**EMERGENCY ALERT ON THE RIDE, "ROUND-UP"  
(by Manco, Hrubutz Mfg, or Kilinski Mfg)**

BULLETIN: BU-134 MC

ROUND-UP/PARATROOPER MAIN SPINDLE SHAFT SAFETY LIMITING RING

## ROUND-UP/PARATROOPER HUB INSPECTION

CENTER HUB ASSEMBLY

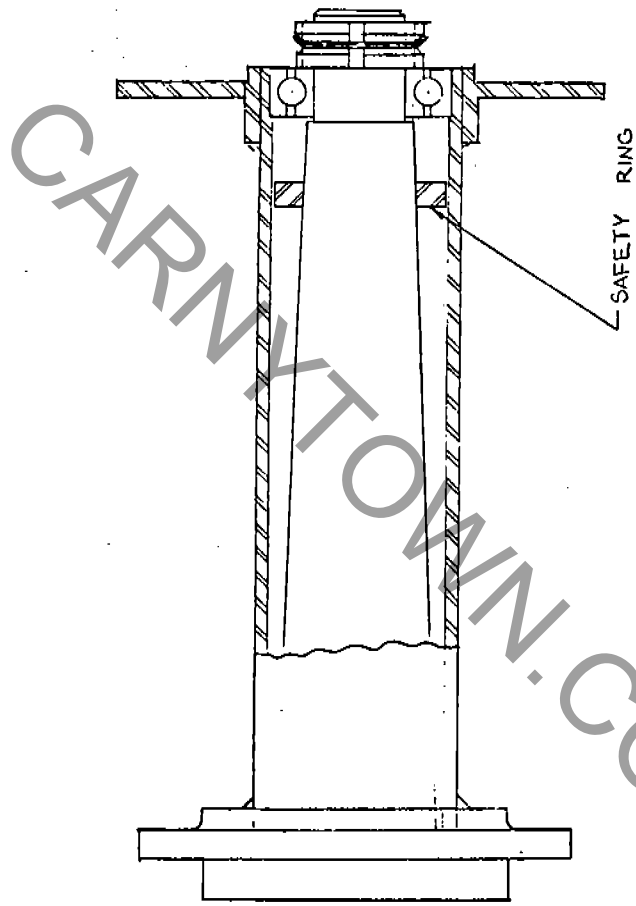
We feel it is necessary for you to take the following preventive measures immediately: (See enclosed drawings RD-35R and FR-503S.)

1. Remove the center ornament and inspect the weld on the hub (shown in drawings RD-35R and FR-503S) for cracks. If there are cracks, ship the hub to Man-Co Mfg.. We will repair, using the design presently being used.
2. Remove the top bearing and visually inspect the bearing and make sure there is a safety limiting ring in place. If there is a limiting ring on your ride, it will be plainly visible on the upper portion of your main spindle shaft. If it is not present, we highly recommend that you add this part immediately. (Part #STD 353)

DRAWN BY: SWJ	DATE: 9-1-88	SCALE: NONE
CENTER HUB - INSPECTION OF WELDS		
ROUND-UPS & PARATROOPERS		
		BO-136

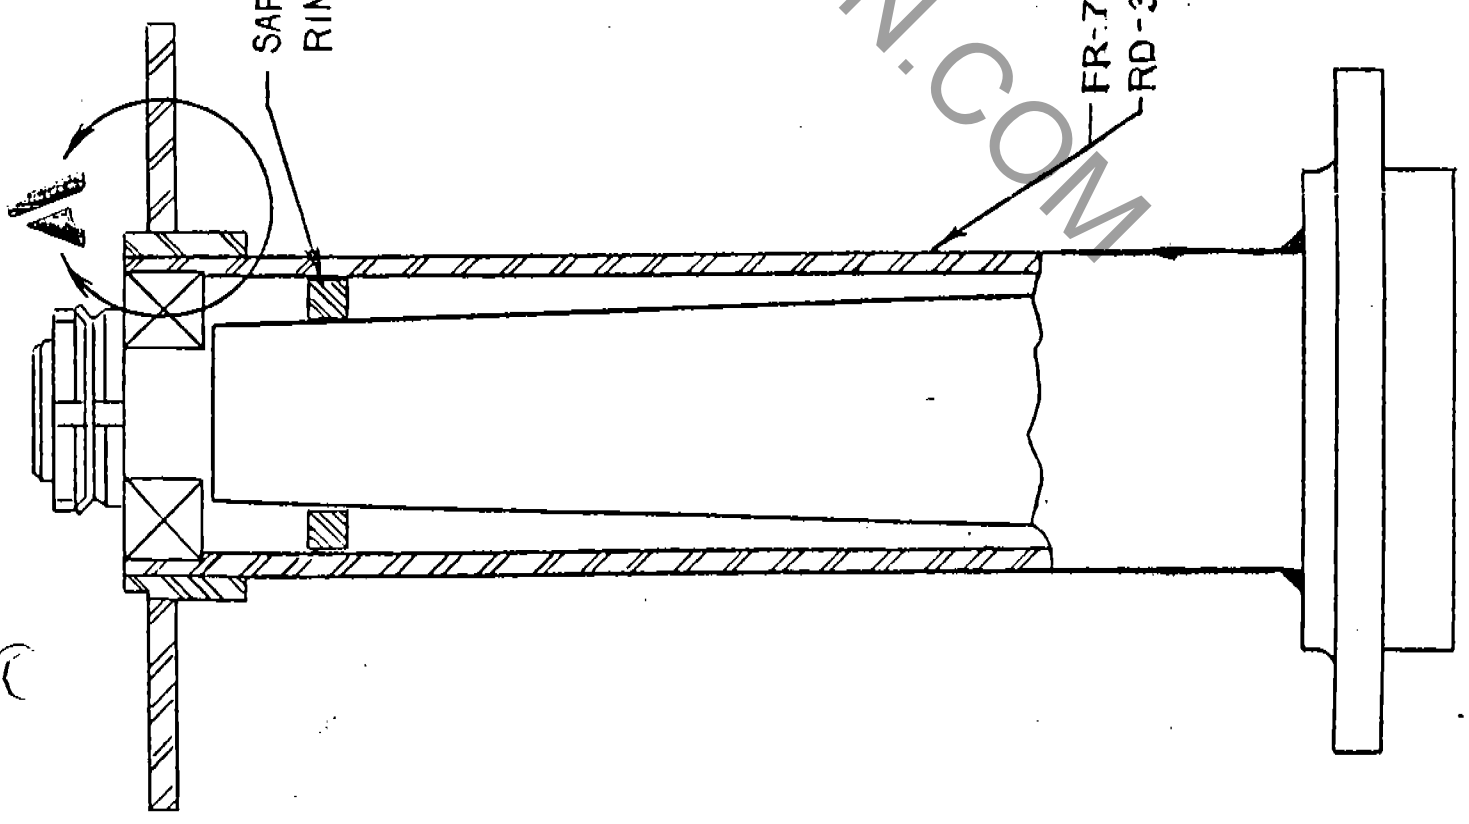
AREA TO BE MAGNAFLUXED FOR CRACKS

IF CRACK IS NOTED IN THIS AREA, CENTER HUB SHOULD BE REPLACED

The main spindle shaft hub housing on the Round-Up and Paratrooper amusement rides that were manufactured by Frank Hrubetz Co., and Kilinski Mfg. Co. (KMC) have shown some sign of fatigue cracks in the weld areas of the hub assemblies.

We at Man-Co feel that this is something that should be inspected on a more regular basis and so we are recommending that the welds shown in the attached drawing (BU-136-MC) be inspected annually. If any sign of stress or cracks are noted, then we recommend that the entire hub assembly be replaced for the safety of the ride owners and customers.

**NO. SK-41285**

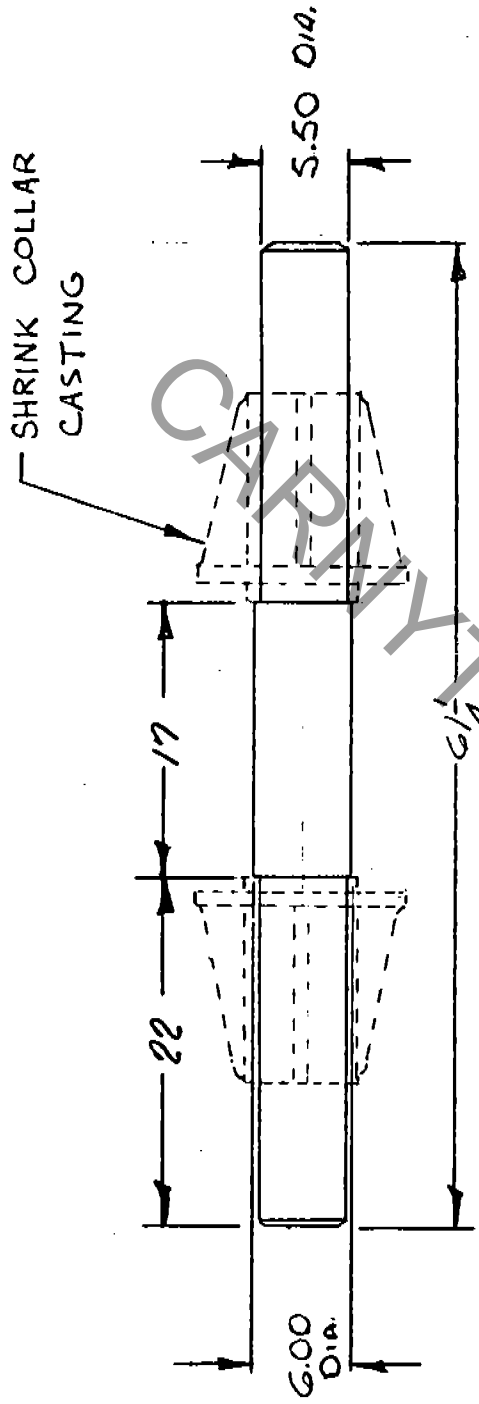
In early June 1993, a Round-Up ride experienced a failure of a weld located on the shrink collar on the main center spindle (two drawings are attached for reference). This is the first known occasion for this style of shaft to fail since the manufacturer's Bulletin requiring replacement of an earlier system.

In doing so, the power for the ride needs to be turned off, and the brush holder located at the end of the main boom removed. Once this is completed, the weld that ties the (1) shrink collar to the (2) steel plate needs to be cleaned and inspected. See the first of the drawings for areas marked (1) and (2). Should a visual indication be found, the ride needs to be closed and the K&K Insurance Group, Loss Control Division, notified immediately (219-455-5709).

The weld should be visually inspected immediately and periodically thereafter.

NO. SK-41385

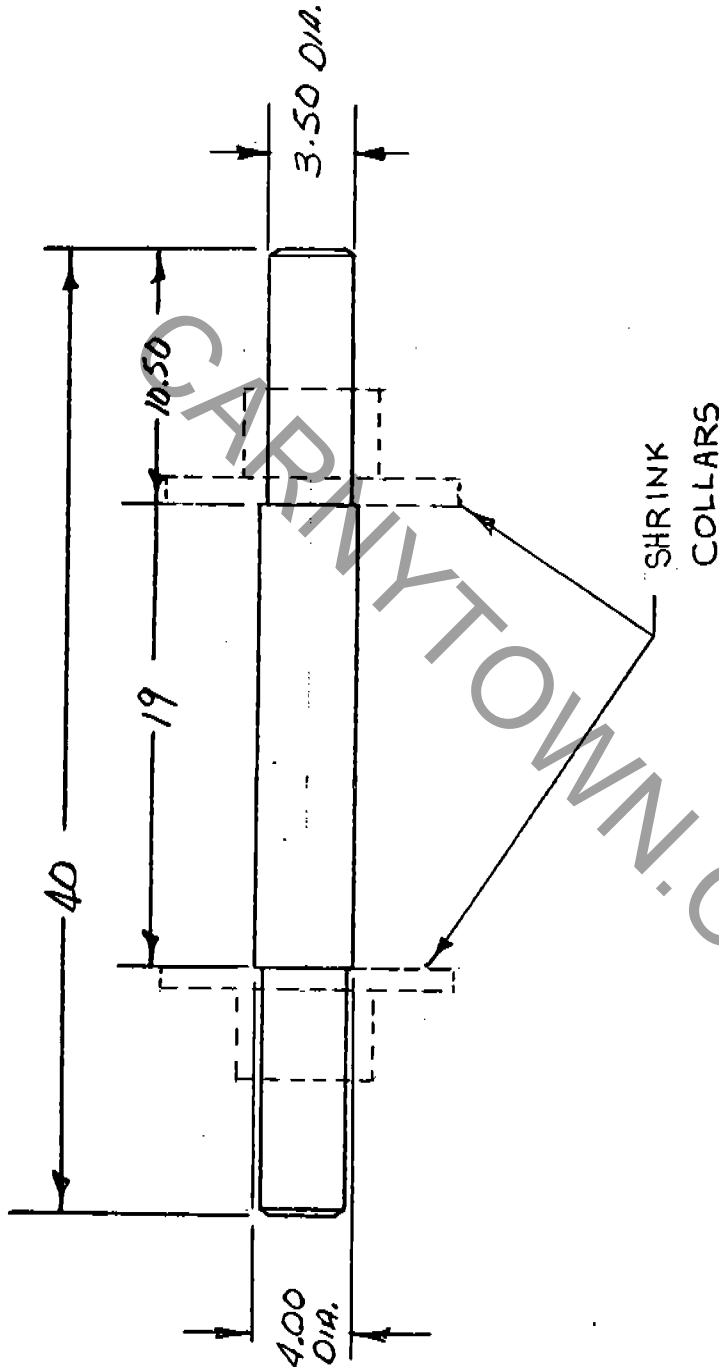
REV	DATE	DESCRIPTION
A	3-17-88	SHOW SHRINK COLLAR

<b>MAN-CO. MFG. INC.</b>		P.O. BOX 13114 SALEM, OR 97309	
SCALE:	DATE:	DRAWN BY:	
NONE	8-31-89	SWJ	
30' FOLDING ROUND-UP		ANCHOR SHAFT	
		BU 138-A

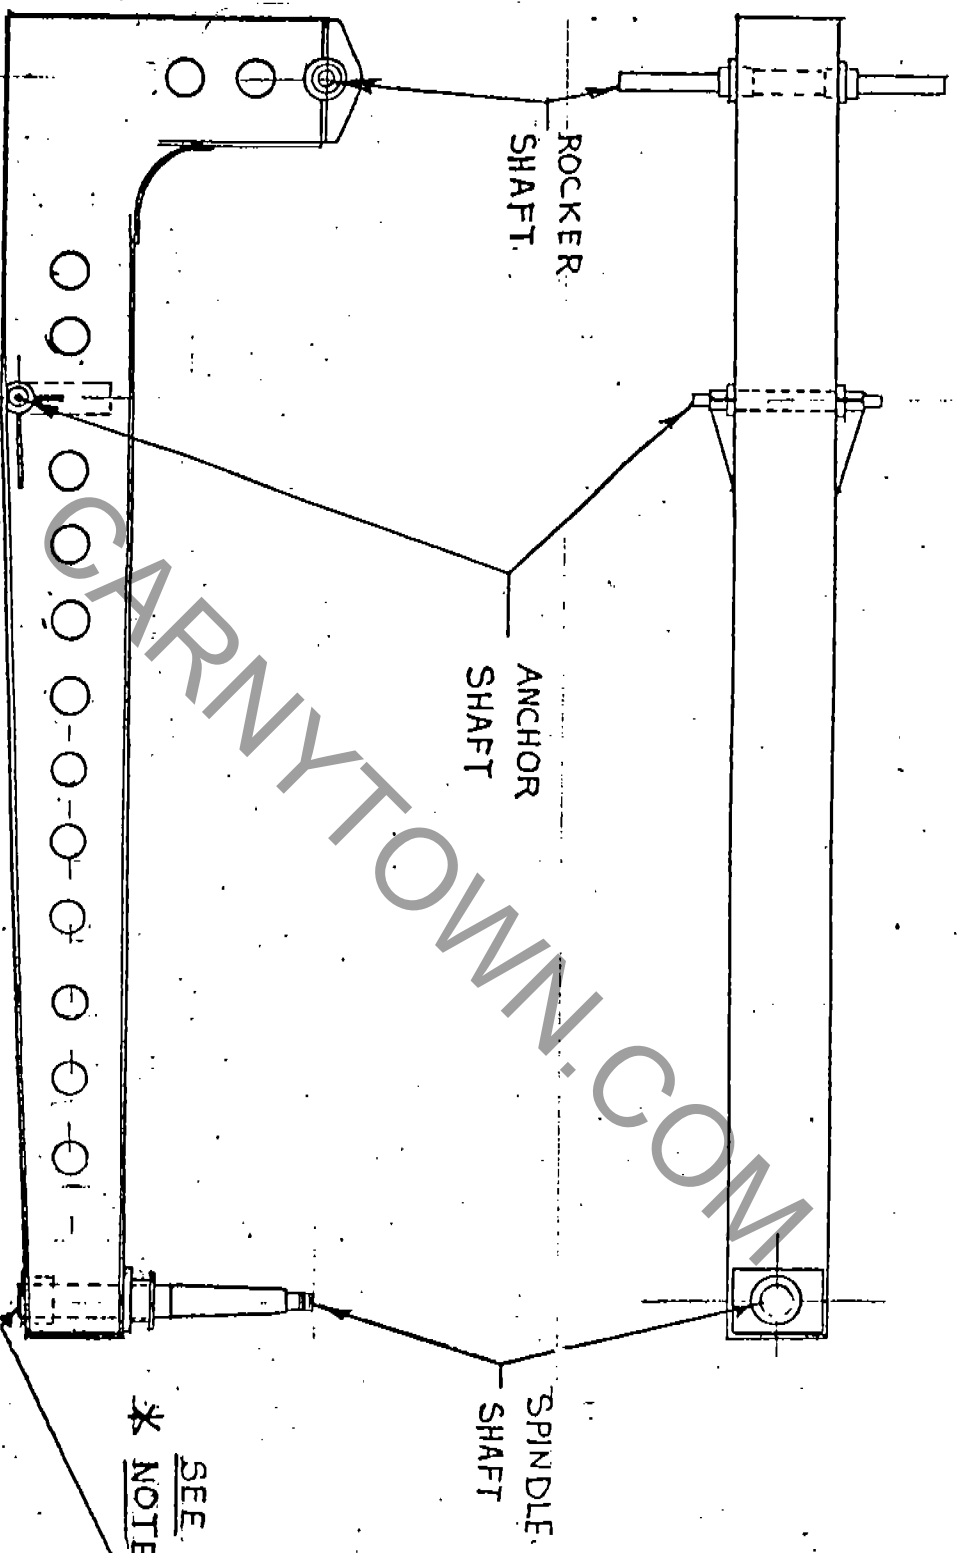
\* NOTE: IF CYLINDER ANCHOR SHAFT HAS THIS APPEARANCE, THEN SHAFT REPLACEMENT IS NEEDED.

- 1) Inspect your ride and determine if the shafts and/or spindles are welded in directly, or if shrink collars are used. (See Drawings BU-138-A through F for information on how to determine the installation method used on your ride.)
- 2) If shrink collars are used on your ride, there is no need for replacement. Please note: All shafts and spindles still need to be tested annually according to the procedures outlined in BU-135-MC (QC-UI-1 - Rev. 3).
- 3) If the shafts and/or spindles on your ride are welded directly to the boom, then replacement is needed.

<b>MAN-CO. MFG. INC.</b> P.O. BOX 13114 SALTM, OR 97139	
MAILU Boom ROCKER SHAFT	
DATE 8-31-89	
DRAWN BY SWJ	
SCALE	
<b>NO. BU 1138-C</b>

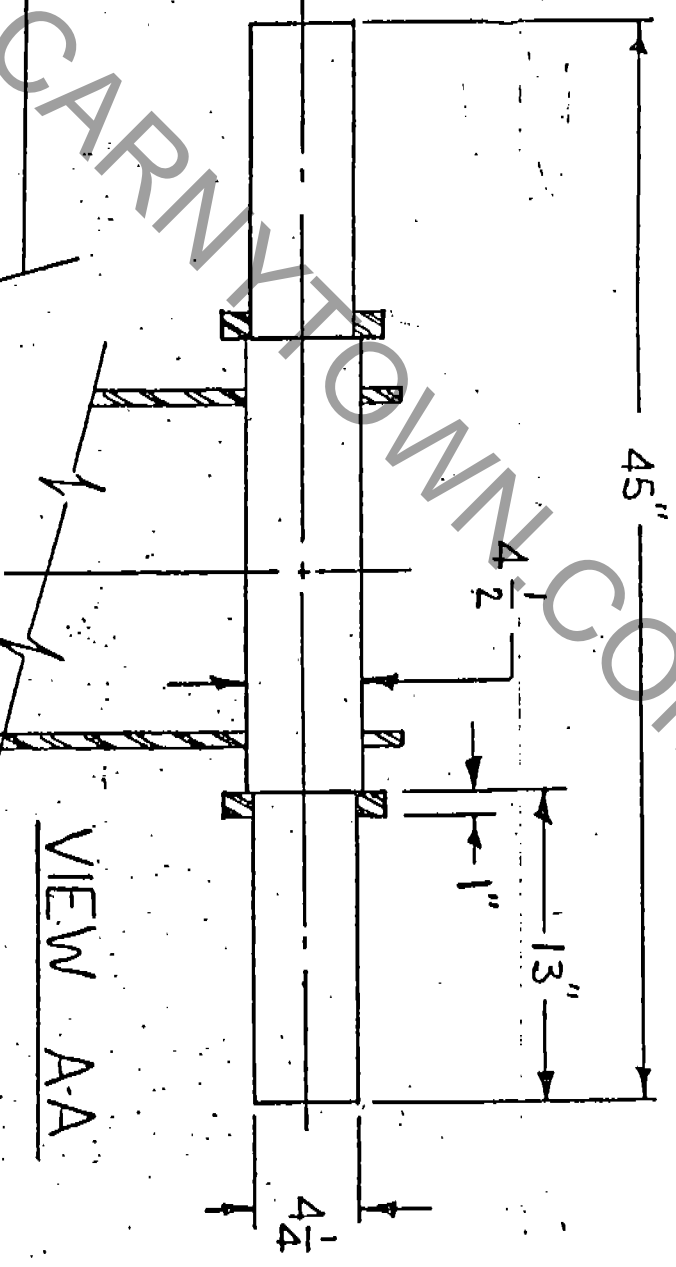
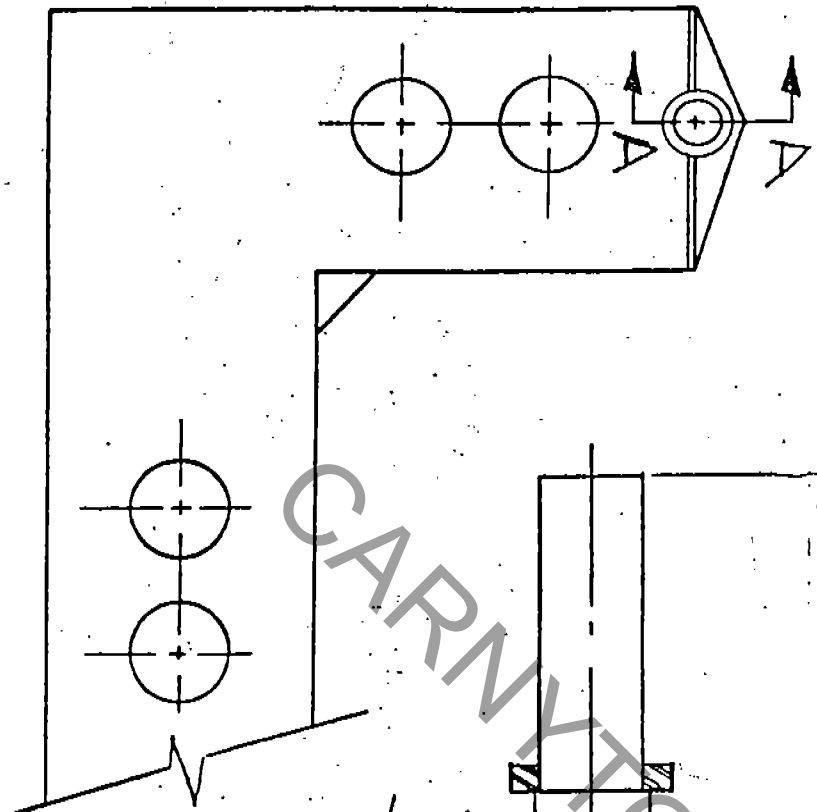
\* NOTE: IF ROCKER  
SHAFT HAS THIS APPEARANCE  
THEN REPLACEMENT OF SHAFT  
IS NEEDED.
